STAFF REPORT  
(Preliminary Plat)

CASE NUMBER: S/D 92-12 - FIRST BIBLE BAPTIST CHURCH  
ADDITION

STAFF REPORT  
(Final Plat, Preliminary Plat Approved 3/19/92)

VICINITY MAP:

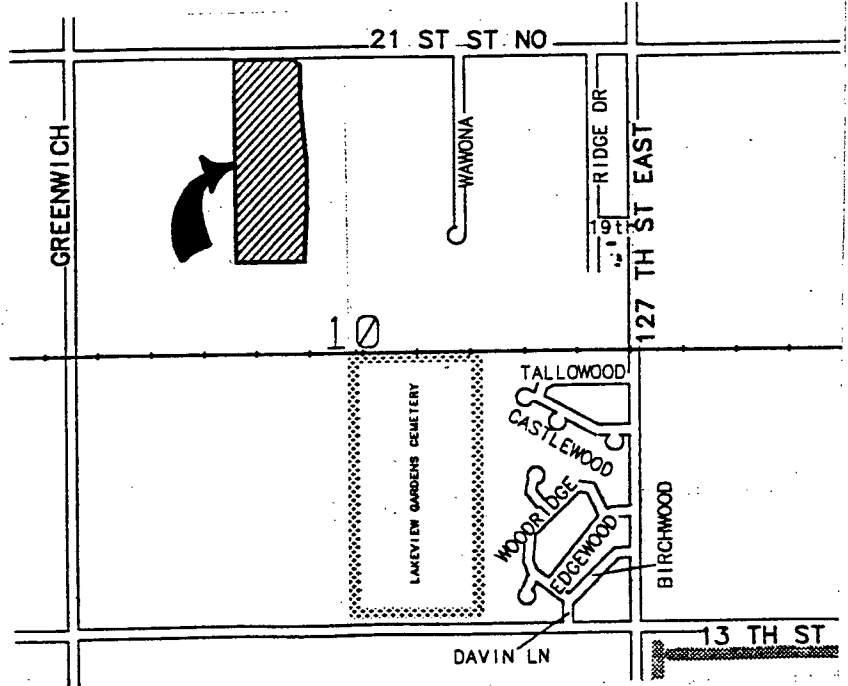
- A. Since neither municipal water nor sanitary sewer is available to serve this property, the applicant shall contact the Environmental Health Division of the Health Department to find out what tests may be necessary and what standards are to be met for approval of on-site sewerage facilities and water wells. A memorandum shall be obtained specifying approval.

- B. The applicant shall guarantee any drainage improvements required by the platting of this property.
- C. If improvements are guaranteed by petition, a notarized certificate listing the petitions shall be submitted to the Planning Department for recording.

- D. As indicated by the FEMA maps for this area, the southern portion of this site may be in or at least near an identified floodway. County Engineering needs to indicate if a floodway and/or minimum building pad elevation need to be platted. If either item is required, the plattor's text shall reference the standard floodway language and/or minimum building pad elevation. Also if applicable, an agreement for maintenance of the floodway shall be submitted.

- E. The final plat shall label the center line of 21st St. N. and clearly indicate the amount of half street right-of-way available.
- F. On the final plat the plattor's text shall reference the dedication of access control to 21st St. North.

- G. Prior to or at the time of submitting the final plat, the applicant shall submit a drainage plan to County Engineering for review and approval.
- H. Requirements for a final plat (see pages 24-29, Part 4, Article 5 of the MAPC Subdivision Regulations).

- I. The applicant shall install or guarantee the installation of all utilities and facilities which are applicable and described in Article 8 of the MAPC Subdivision Regulations.

- J. The applicant's engineer is advised that the Register of Deeds is requiring the name(s) of the notary public, who acknowledges the signatures on this plat, to be printed beneath the notary's signature.

- K. The representative from County Engineering should be prepared to comment on the status of the applicant's drainage concept.
  - L. The City Engineer needs to indicate, based on this site's location to the City of Wichita, if a guarantee for the future extension of municipal water should be required.
-

VICINITY MAP:

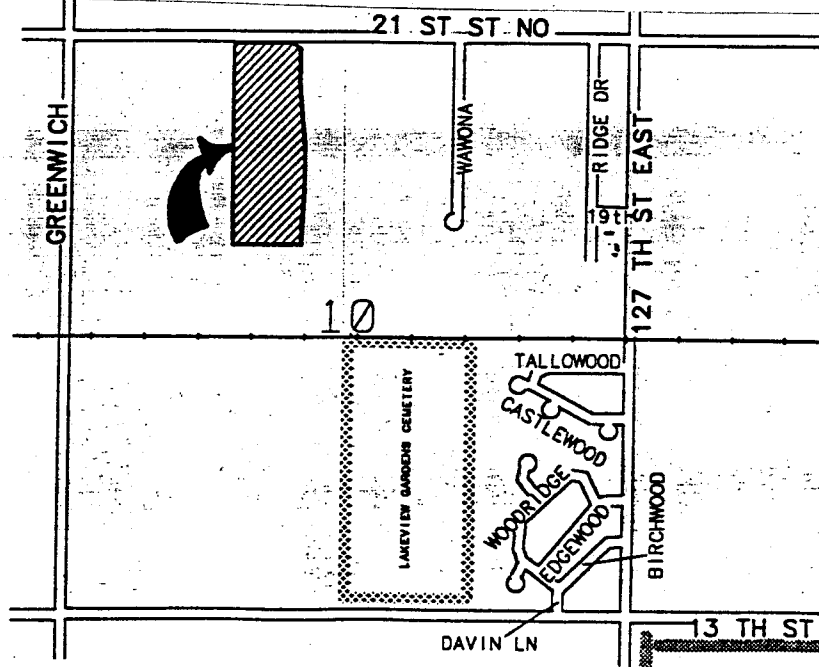
- A. Since neither municipal water nor sanitary sewer is available to serve this property, the applicant shall contact the Environmental Health Division of the Health Department to find out what tests may be necessary and what standards are to be met for approval of on-site sewerage facilities and water wells. A memorandum shall be obtained specifying approval.

- B. To allow for the future extension of municipal water to this site, the applicant shall submit a guarantee for the extension of water across this site's frontage to 21st St. North.

- C. If improvements are guaranteed by petition, a notarized certificate listing the petitions shall be submitted to the Planning Department for recording.

- D. As indicated by County Engineering, a minimum building pad elevation may be needed on the final plat. If required, the plat's text shall note the minimum building pad elevation. It shall be noted if the elevation is for the lowest opening or level. Also, on site and off site benchmarks shall be indicated.

- E. An agreement shall be submitted concerning the maintenance of the floodway and the County's right to maintain the floodway if necessary and charge back any costs to the property owner.

- F. The applicant shall install or guarantee the installation of all utilities and facilities which are applicable and described in Article 8 of the MAPC Subdivision Regulations.

- G. The applicant's engineer is advised that the Register of Deeds is requiring the name(s) of the notary public, who acknowledges the signatures on this plat, to be printed beneath the notary's signature.

- H. Perimeter closure computations shall be submitted with the final plat tracing. Section 5-101(c).
- I. Recording of the plat within 30 days after approval by the City Council.

- J. The representative from the County Engineer's office should be prepared to comment on the status of the applicant's drainage plan. Also, Engineering needs to indicate if minimum building pad elevations are required and the adequacy of the indicated floodway. Further, Engineering needs to indicate if this site is within a County sanitary sewer area and if any requirements are needed concerning the future extension of sewer to this site.
